Application/Control Number: 10/628,613

DETAILED ACTION

Claims 1-4, 9, 10, and 12 stand rejected under 35 U.S.C. 102(b) as being anticipated by Asamoto (US patent no. 3,945,676).

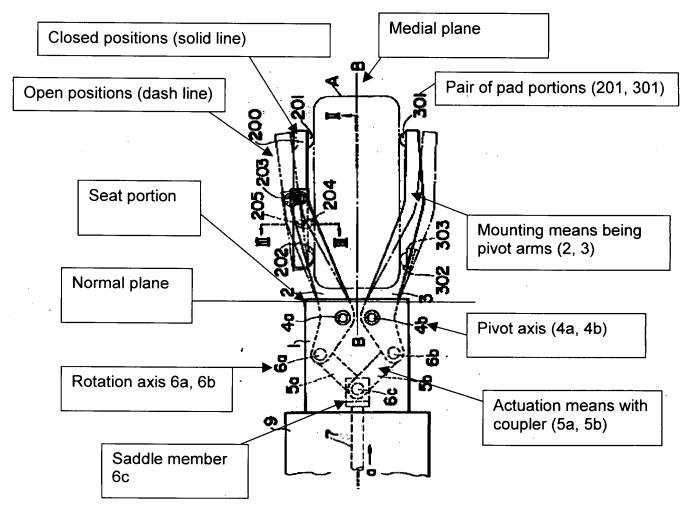
Asamoto discloses a clamp apparatus having all the claimed features of applicant's invention as illustrated below.

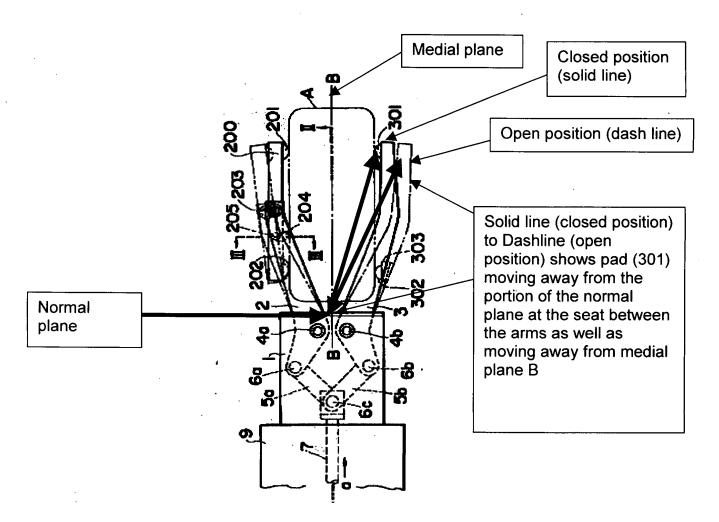
Applicant's arguments filed 7/18/2007 have been fully considered but they are not persuasive. Applicant amendment to the claims did not overcome the rejection on sections 102 and 103 based on Asamoto and Asamoto in combination with Wood III. Asamoto does show "during movement **from closed** positions (solid lines as shown below) **to open** positions (dash lines as shown below), the pad portions move in a

respective directions away from the normal plane (normal plane portion between the two arms) and the medial plane B".

Again applicant's recitation does not overcome Asamoto as illustrated below.

Asamoto's pad portions movement is moving away from the normal plane portion at the seat between the arms and away from the medial plane portion between the arms.

As discussed previously, the medial plane and the normal plane extends through to either side of the pad motion, such that the pad can be said to move away or toward the planes from the closed to open or vice versa which says such limitation is meaningless as direction goes and does not overcome Asamoto at all.
